# INTERNATIONAL BUILDING CODE – STRUCTURAL

## S3-09/10-PART I

### Proposed Change as Submitted

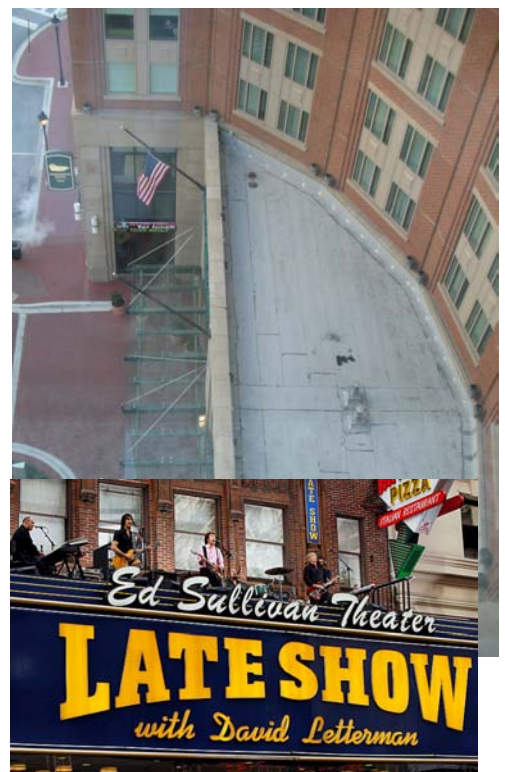
Cornices are not defined in the IBC, yet they are listed in Table 1607.1, Item 11 with a live load of 60 psf.

Currently, a Marquee must project over the public right-of-way. It is listed in Table 1607.1, Item 24 with a live load of 75 psf. If it doesn't project over the public right-of-way, what is it and what live load should it be designed for? The chapter-by-chapter synopsis for Chapter 32 on page xii of the 2009 IBC notes that "steps, columns, awnings, canopies, marquees, signs, windows, balconies and similar architectural features above grade" can all encroach into the public right-of-way. This effectively negates the definition of a marquee.

*The photo at the right was taken during the Code Development Hearings in Baltimore at a nearby hotel which had a Marquee that would not meet the current definition of a Marquee because it is not "project into the public right of way". However, access would be available from the operable windows of the adjacent rooms.*

**FIGURE 1609**  
**BASIC WIND SPEED (3-SECOND GUST)**

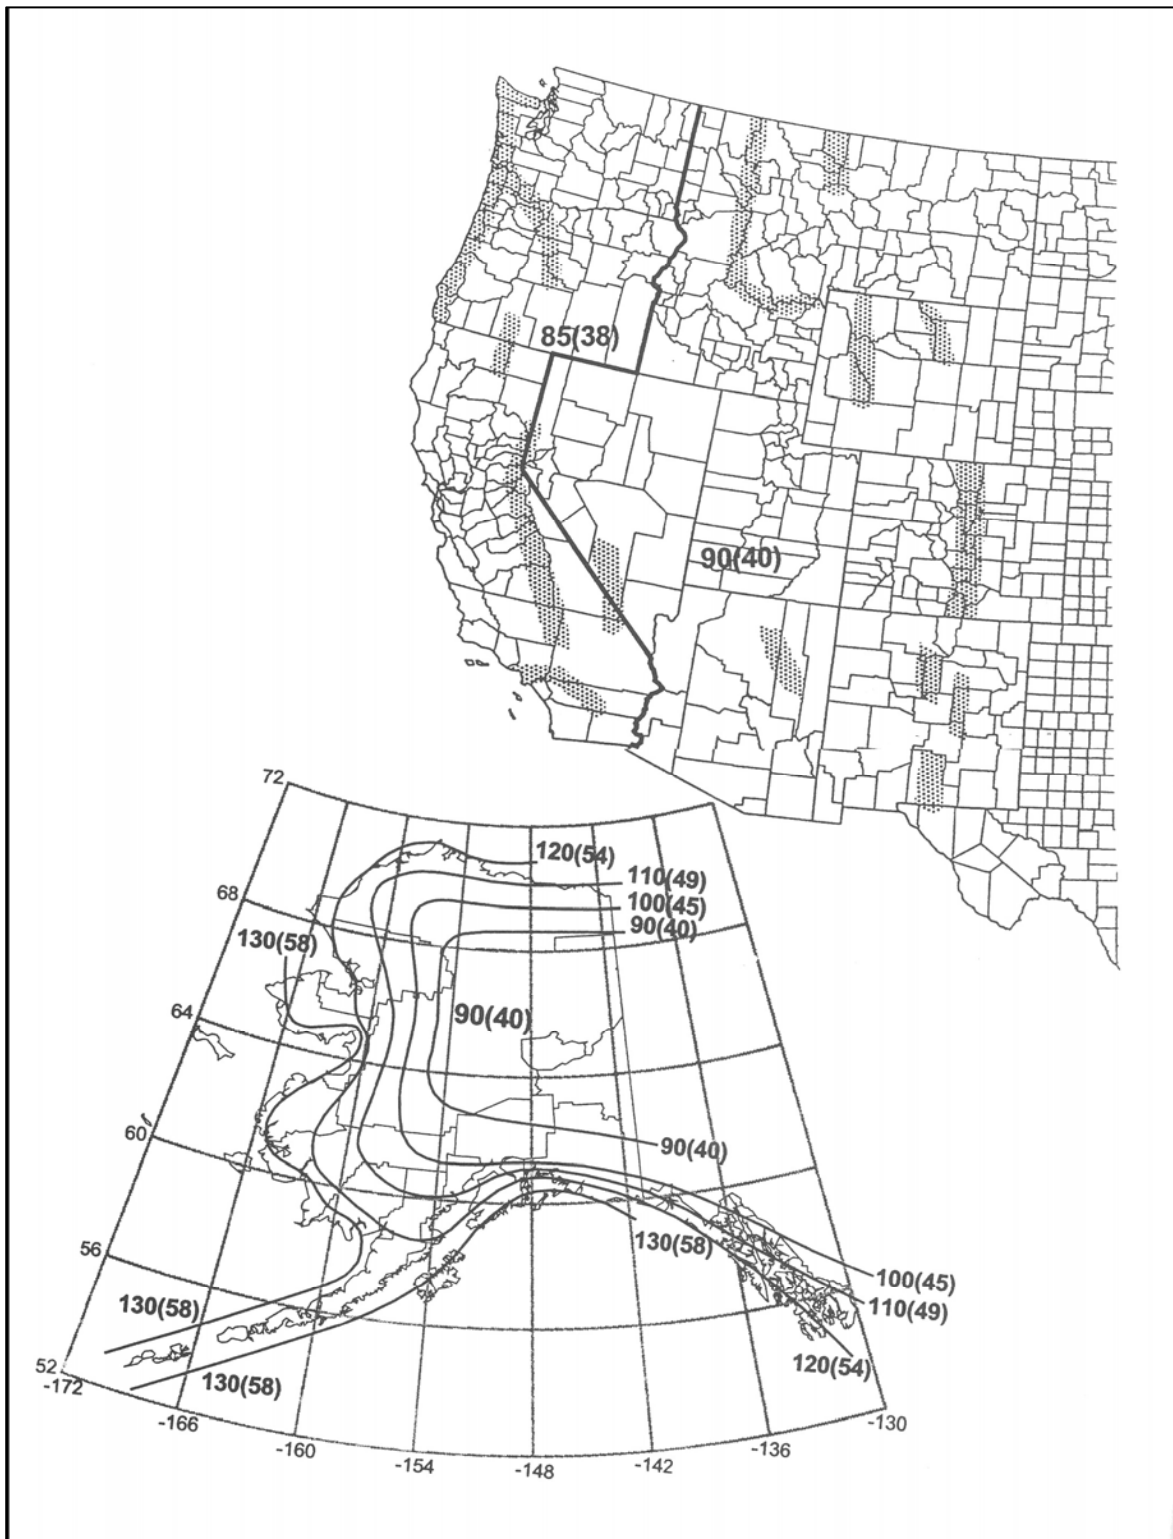
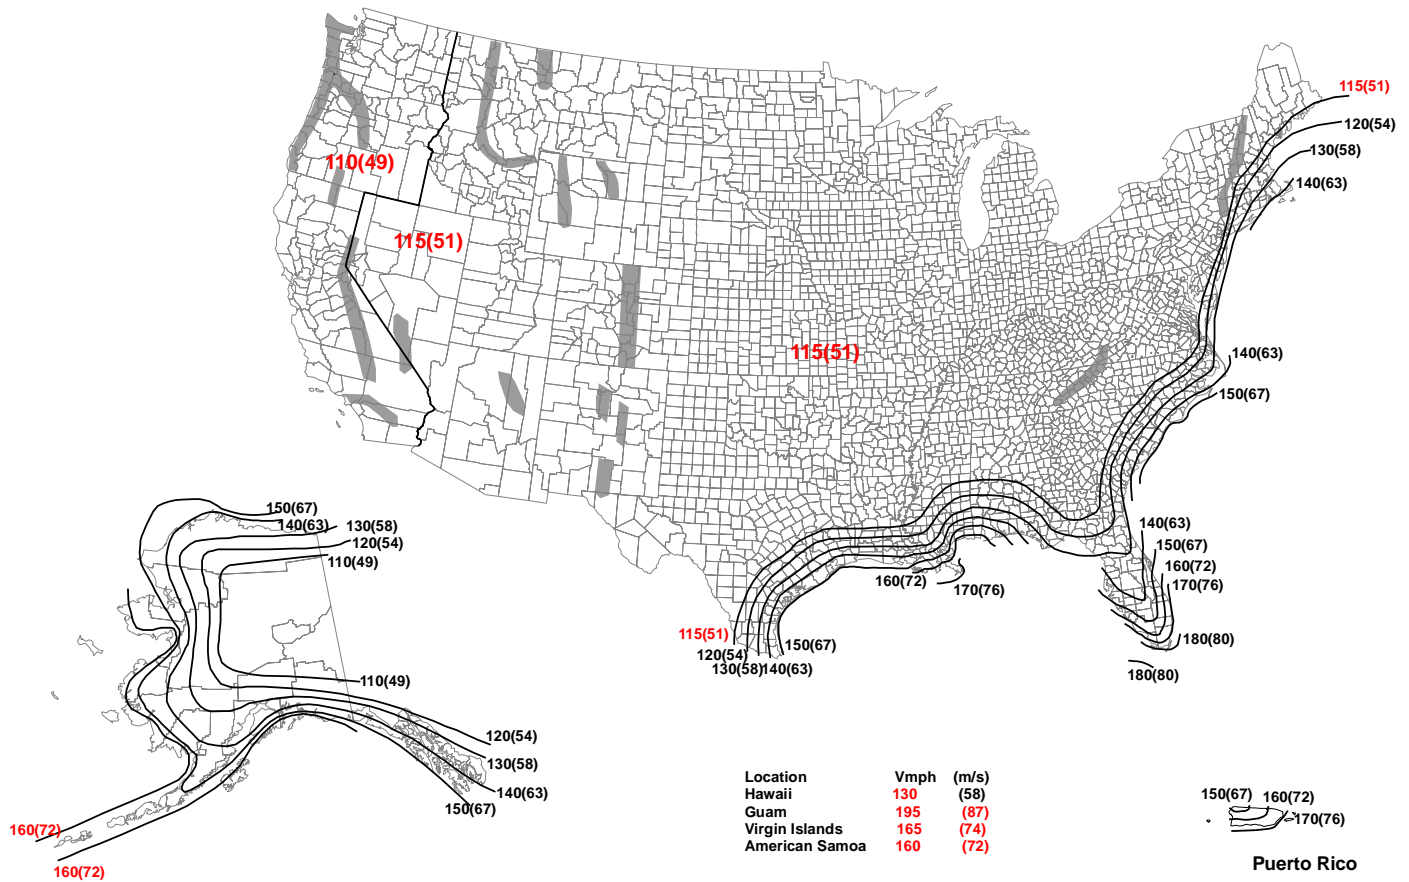
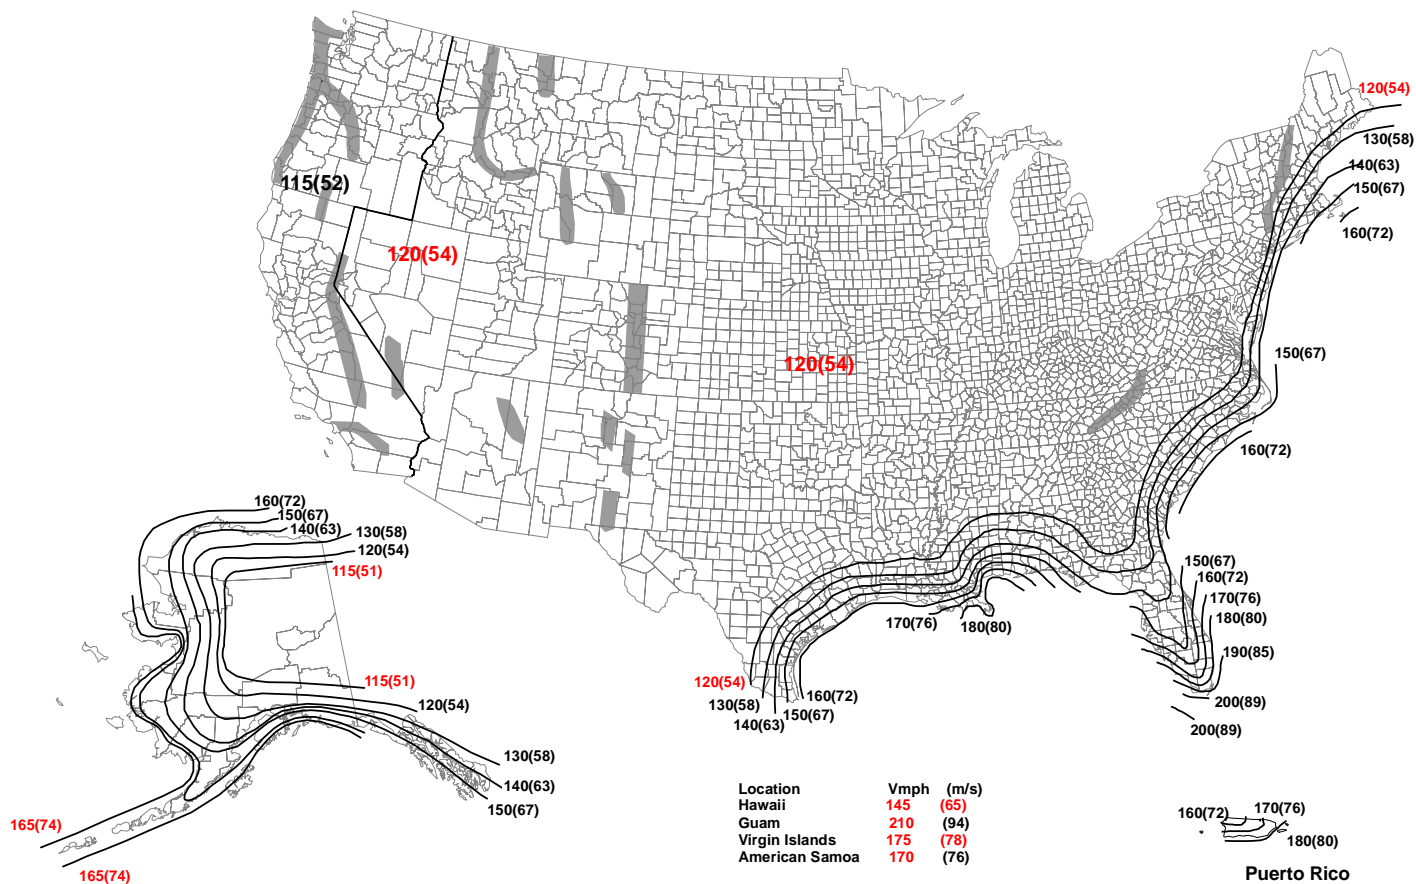
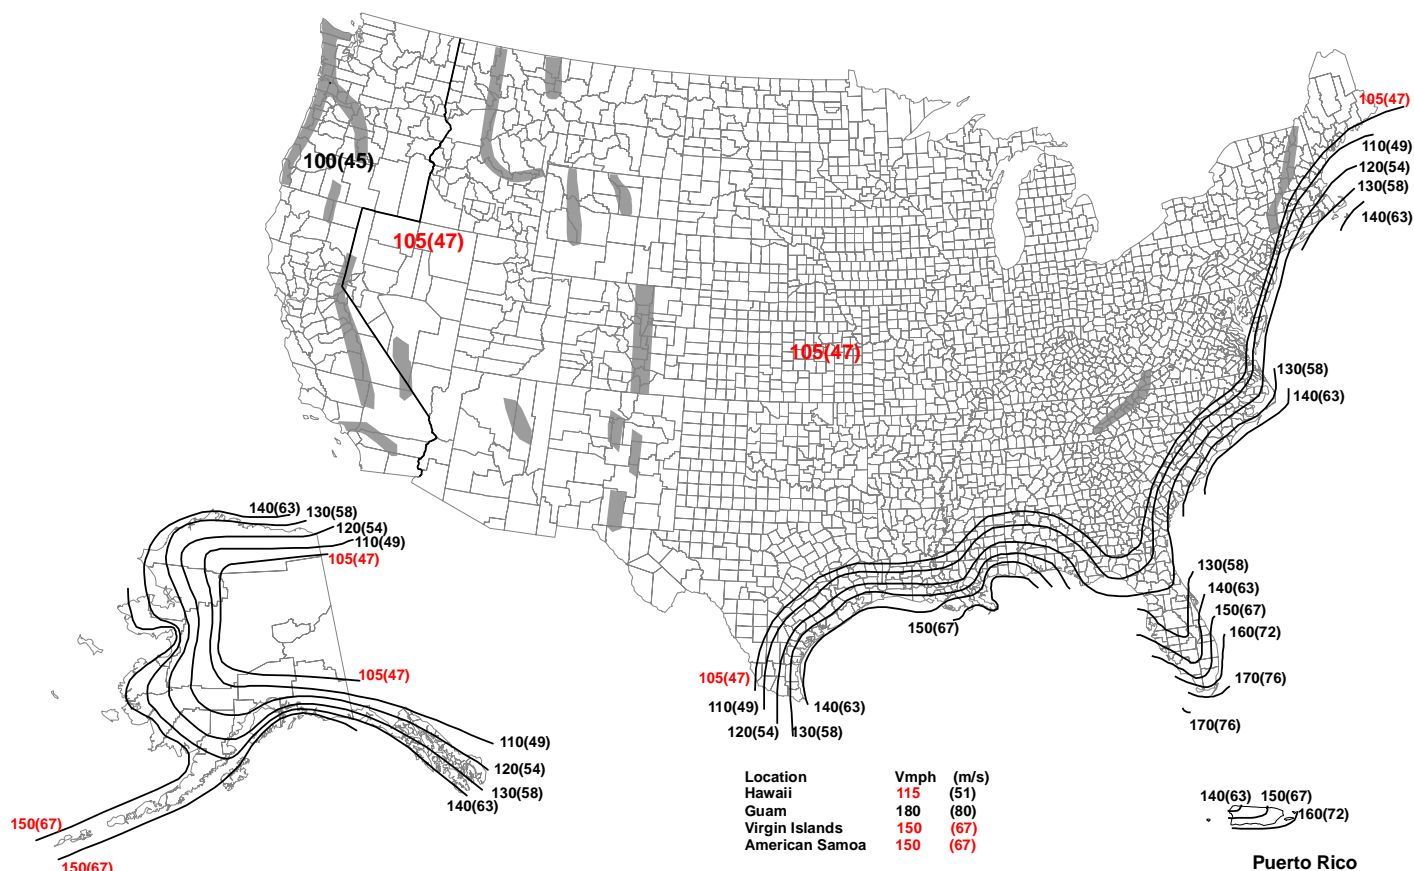
**1609.3 Basic wind speed.** ~~The basic ultimate design wind speed  $V_{ult}$ , in mph, for the determination of the wind loads shall be determined by Figure 1609 Figures 1609A, 1609B and 1609C. The ultimate design wind speed,  $V_{ult}$ , for use in the design of Occupancy Category II buildings and structures shall be obtained from Figure 1609A. The ultimate design wind speed,  $V_{ult}$ , for use in the design of Occupancy Category III and IV buildings and structures shall be obtained from Figure 1609B. The ultimate design wind speed,  $V_{ult}$ , for use in the design of Occupancy Category I buildings and structures shall be obtained from Figure 1609C. Basic The ultimate design wind speed,  $V_{ult}$ , for the special wind regions indicated, near mountainous terrain and near gorges shall be in accordance with local jurisdiction requirements. Basic The ultimate design wind speeds,  $V_{ult}$ , determined by the local jurisdiction shall be in accordance with Section 26.5.1 6.5.4 of ASCE 7.~~

10. Delete and substitute as follows:

**1609.3.1 Wind speed conversion.** When required, the ~~3-second gust basic ultimate design~~ wind speeds of Figure 1609A, B and C shall be converted to nominal design wind speeds,  $V_{asd}$ , fastest-mile wind speeds,  $V_{fm}$ , using Table 1609.3.1 or Equation 16-32.
